MEMORANDUM

Subject: Village Square Development
3095 Albany Post Rd
Buchanan, New York

Kimley-Horn provides the following responses to comments provided by Colliers Engineering & Design in their letter of July 24, 2023:

Figure 4C-3. Warrant 3, Peak Hour

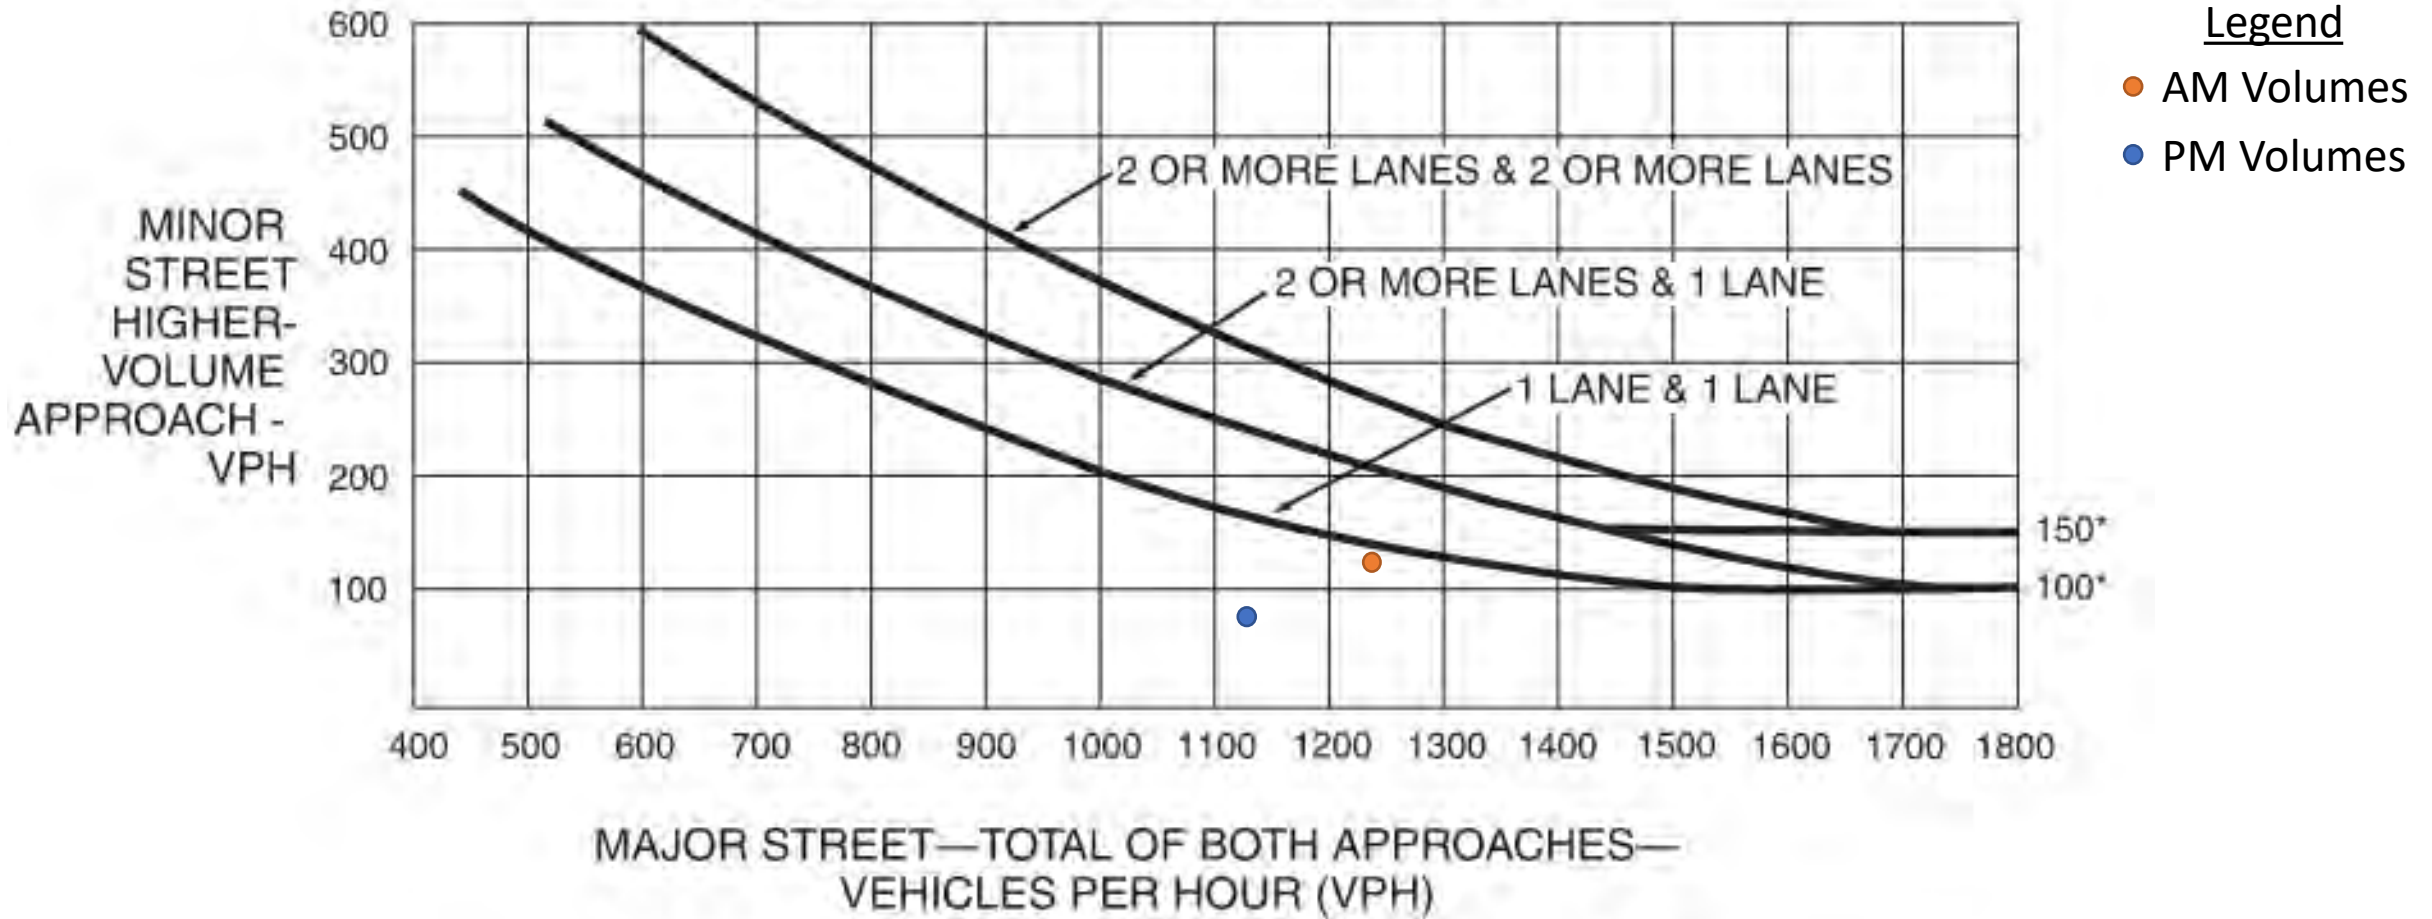
14. The Traffic Signal Warrant Analysis indicates that a traffic signal is not warranted at the intersections analyzed. However, NYSDOT will have to review this to make a determination based on the local conditions. An additional warrant analysis should also be completed for Route 9A/Lake Street for the volume conditions without the separate Route 9A driveway.

Response: An additional warrant analysis was conducted for Route 9A/Lake Street for the volume conditions without the separate Route 9A driveway for the peak-hour and 4-hour conditions. The result of this analysis indicated that the peak-hour warrant is not satisfied by either of the peak hours and that only the AM peak-hour meets the four-hour signal warrant requirements. Based on these findings, it is unlikely that the NYSDOT would approve the installation of a traffic signal for 51 residential units, a coffee shop, a school bus depot and six tennis courts. However, we agree that NYSDOT will have to review this to make a determination on this issue based on the local conditions.

Available Sightlines

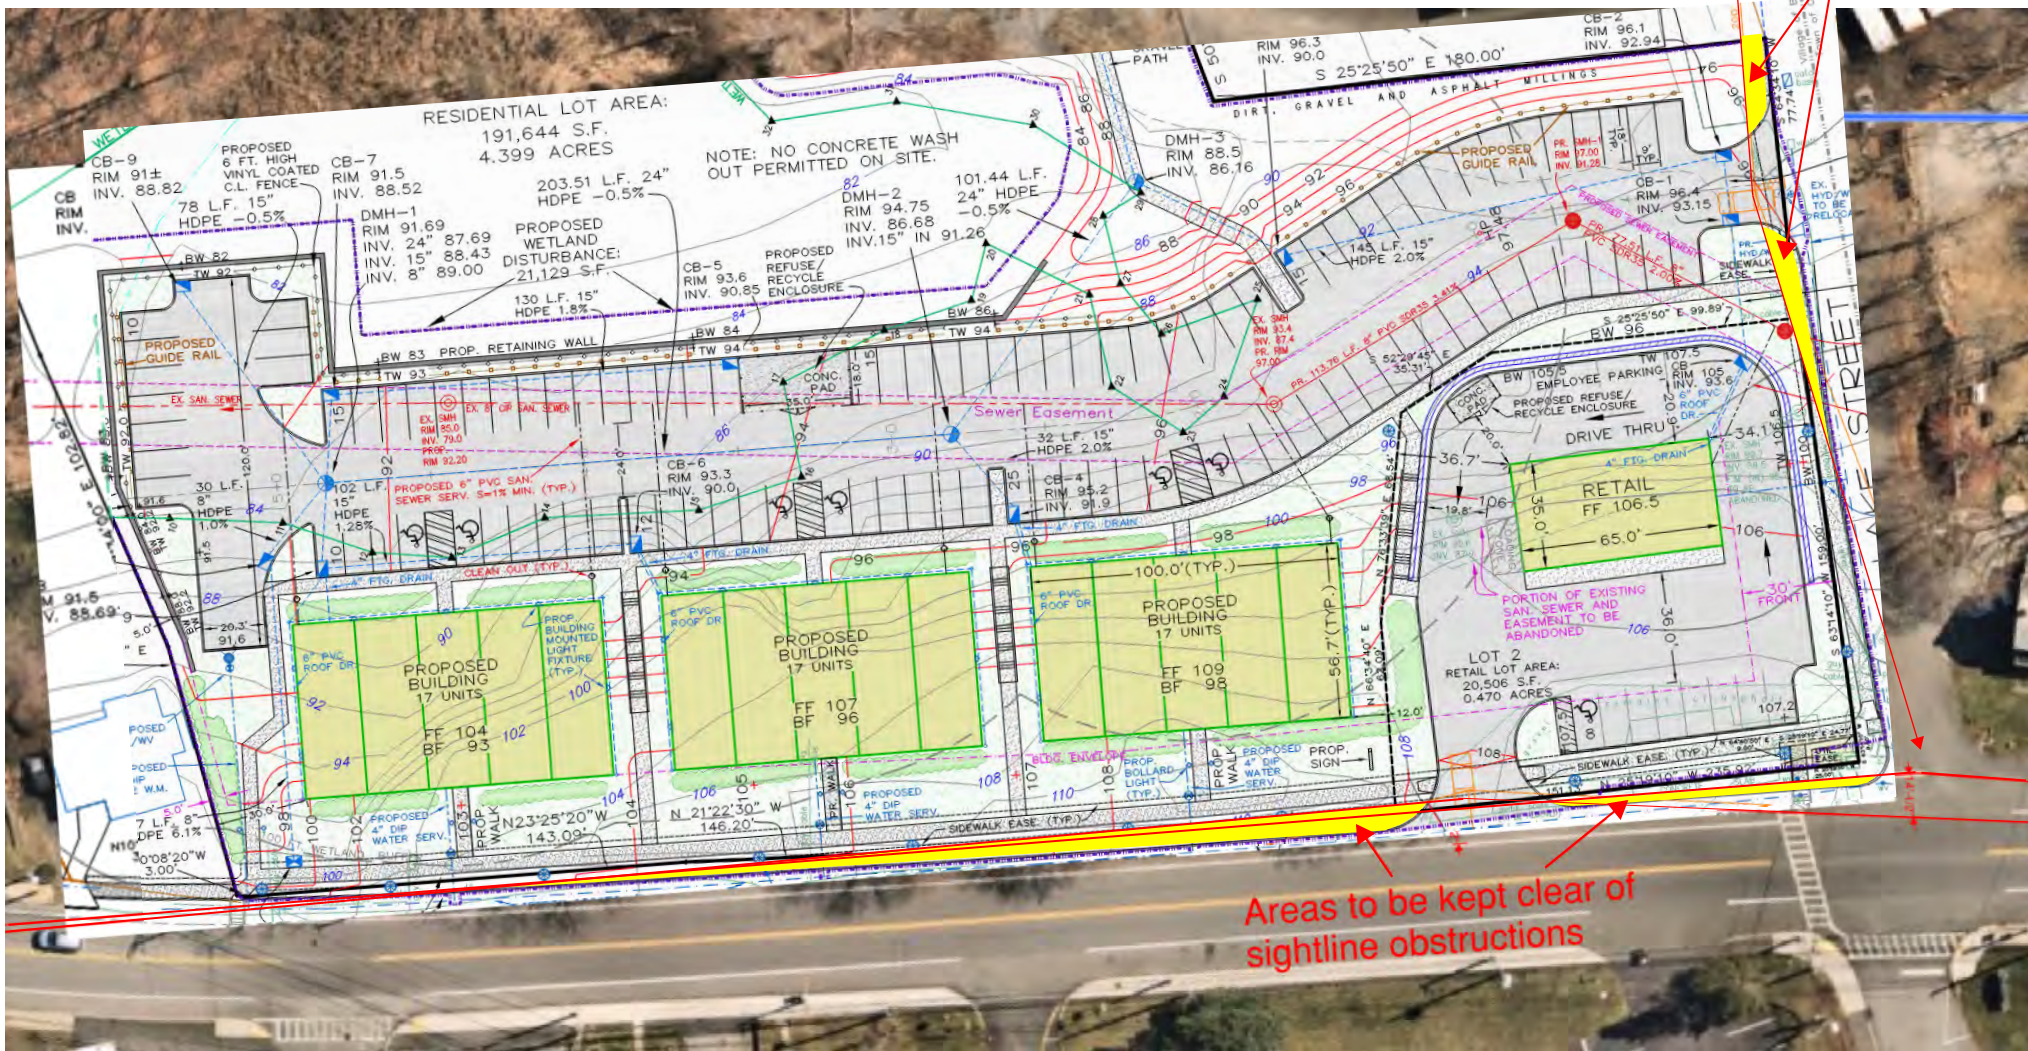
13. The proposed access connections should be reviewed in terms of the sight distances provided and compared to AASHTO and NYSDOT Standards. The sight distance evaluation should include a review of both Stopping Sight Distance (SSD) and Intersection Sight Distance (ISD) for the proposed access connection to Route 9A and Lake Street.

Response: The posted speed limit on Albany Post Road is 30 mph and the 85th percentile speed is 37 mph⁴. Albany Post Road is generally straight and flat in the vicinity of the site and the roadway is not part of the National Highway system. Assuming that motorists should be able to stop safely while traveling at the 85th percentile speed and that the Village would want motorists to travel at the posted design speed, intersection and stopping sight distances for the site access points were calculated as follows⁵:

As shown on the attached exhibit, an inspection of conditions at the site access points on Albany Post Road indicates that the above sight distances can be accommodated (485' and above sight distances are available). The areas to be kept clear of sightline obstructions are shown on the exhibit (and below).

SU-30 garbage or delivery vehicle at Coffee Shop

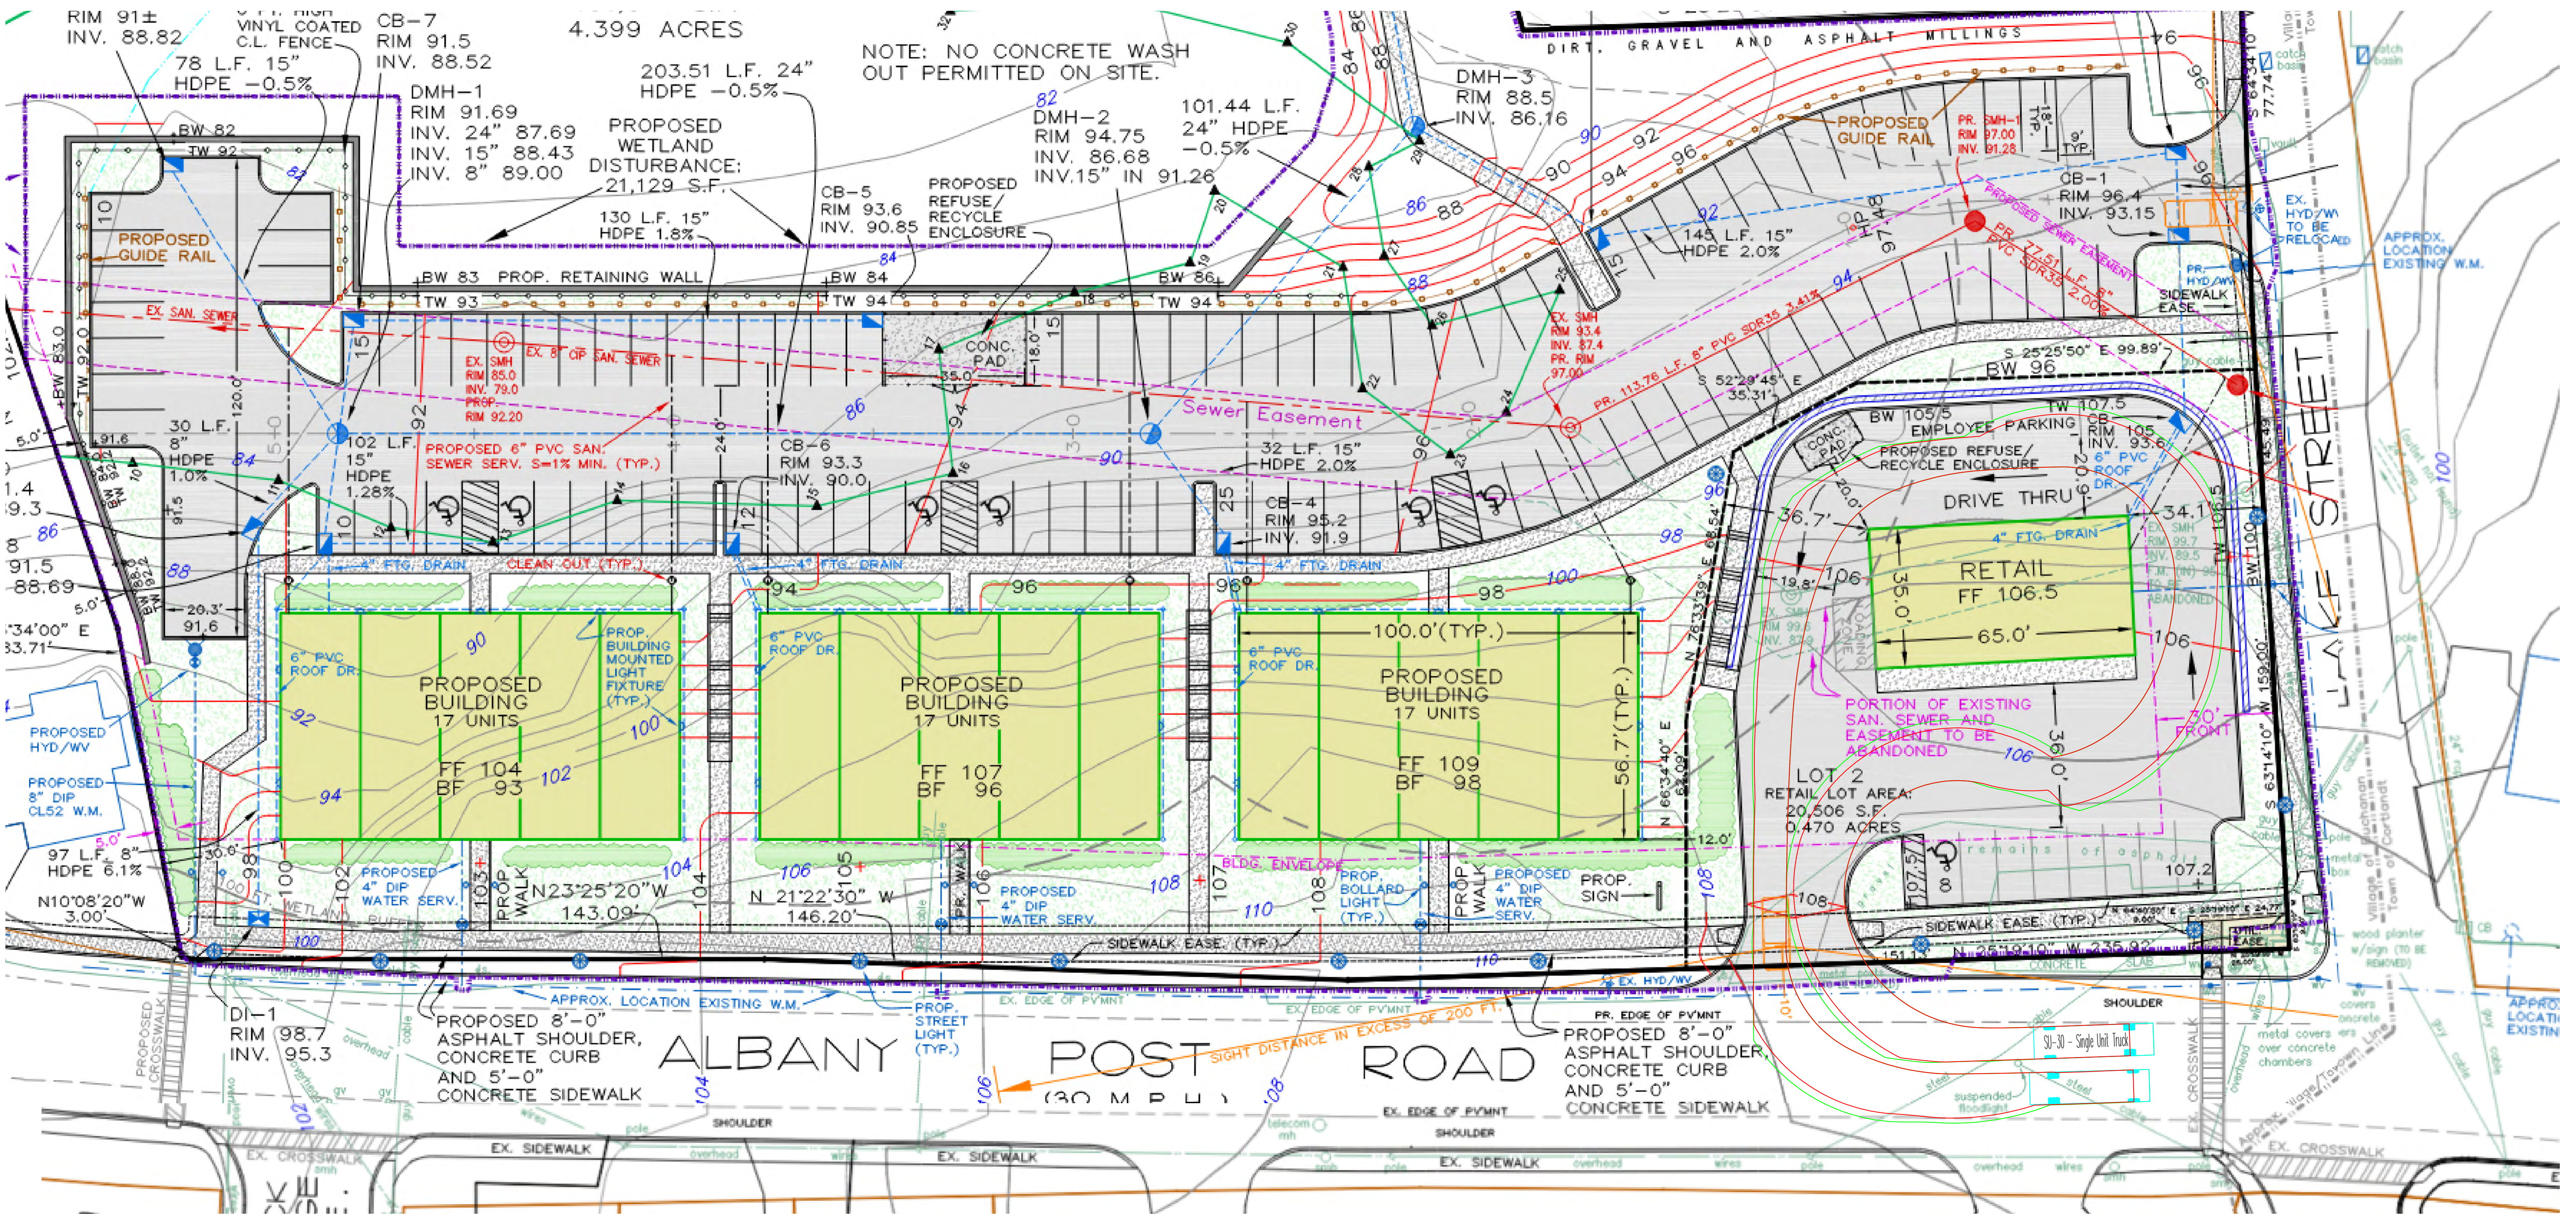
18. Vehicle turning tracks should be provided to indicate whether or not all vehicle types can adequately maneuver through the driveway as well as the adjacent Route 9A/Lake Street intersection.

Response: Vehicle turning tracks have been provided to indicate that all vehicle types servicing the Site can adequately maneuver through the driveway as well as the adjacent Route 9A/Lake Street intersection.
